ENVIRONMENTAL BOARD MOTION 0716084a-001

ITEM FOR ENVIRONMENTAL BOARD AGENDA

**NAME & NUMBER
OF PROJECT:** Wildflower Commons/PUD
C814-06-0233

SUBJECT: Corrections to ERM's August 22, 2007 memo regarding Critical Environmental Feature setbacks of Wildflower Commons.

Map 1: Setback Area Location Map

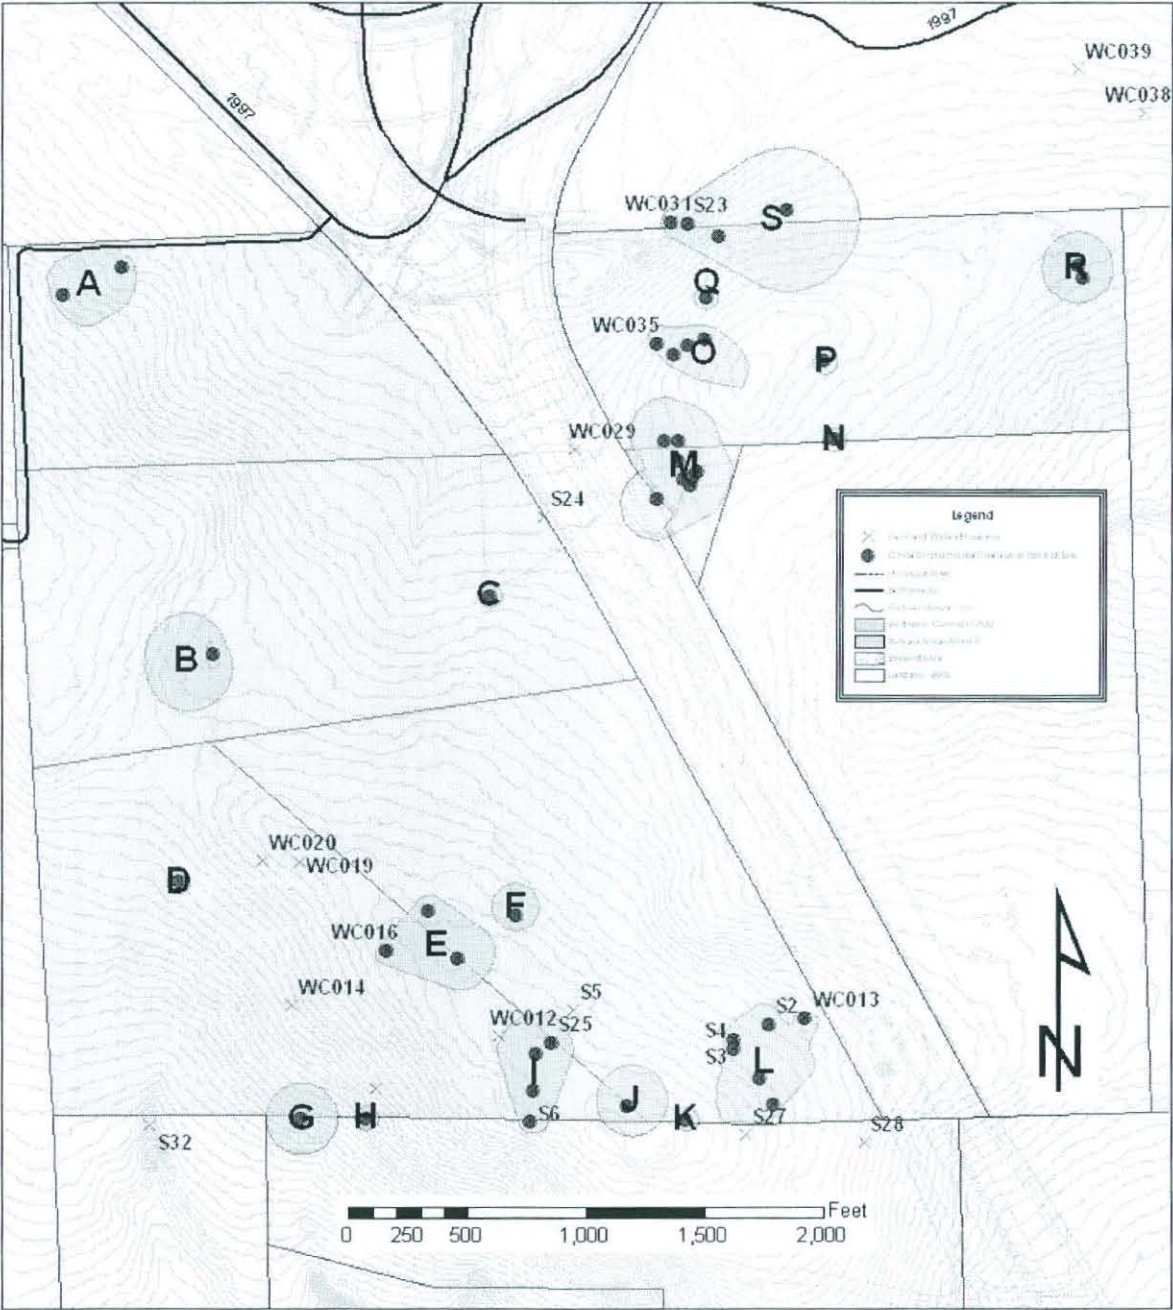
Our surveys covered about 90 percent of the property. However, a layer of mulch and several brush piles from tree removal and clearing activities impeded our view of the ground in several areas. Although our survey efforts was hampered in some areas, we were able to identify 35 additional recharge features on or within 300-ft of the site. In all, 67 recharge features were identified by Harper's 2003 and the City's 2007 karst assessments. ERM staff has determined that 49 of the 67 features are critical environmental features (48 recharge features and 1 wetland/sinkhole). These features are located on or within 300-ft of the Wildflower Commons site. Table 1 lists all the features identified by both surveys and a corresponding location map (Map 1) is attached.

Based the surface drainage patterns, 2-ft topography, the type of feature, the feature's size and the density (or clustering) of features, ERM staff is recommending protecting the critical environmental features with 19 critical environmental feature setback areas (Labeled A thru S). The attached map shows the location of the setback areas. ERM staff is recommending that the CEFs and their associated setback area (or buffers) are documented within the PUD ordinance along with the following Land Development Code (LDC) requirements from Section 25-8-281.

1. No residential lots may include a CEF or be located within 50 feet of a CEF.
2. Setback areas must be established to protect all CEFs. Although the LDC allows a portion of the CEF buffer to be included in a residential lot, I do not recommend that this be allowed. Residential lots should not include any portion of a CEF buffer. Setbacks must comply with the setback area has stated in Table 1 and shown Map 1. ERM is willing to revise setback areas listed in Table 1 and shown on Map 1 during PUD process, if the applicant provides more detail

1. All CEFs must be shown on a topographic map (or maps), and listed in a summary table and included on an exhibit (s) in the PUD ordinance. The table must include the identification of the CEF, the type of CEF, and the recommended setback area. All maps must have north arrow and reference scale.

2. All CEFs and associated CEF buffers are to be shown on all plats, preliminary plans, site plans and construction plans. The PUD ordinance and the plat notes must have a following statement "all activities within the critical environmental feature setback must comply with Section 25-8-281(c)(2) of Austin's Land Development Code. This section states that the natural vegetative cover must be retained to the maximum extent practicable; construction is prohibited; and wastewater disposal or irrigation is prohibited this requirement."

3. No utilities are allowed within CEF buffers.
4. Fencing is required at the edge of all CEF buffer areas that are within limits of construction. Fencing must be 6 feet in height. Wrought iron or vinyl-coated chain link are acceptable. Access gates with a lockable latch are to be provided for each buffer.

5. Fencing at the edge of CEF buffers must be installed prior to the initiation of construction.
6. Water quality BMPs should not drain directly into CEF setback area. Level spreaders or similar structures must be used to overland sheet flow stormwater before it discharges near CEF setback areas. Stormwater irrigation must occur outside the CEF setback areas.
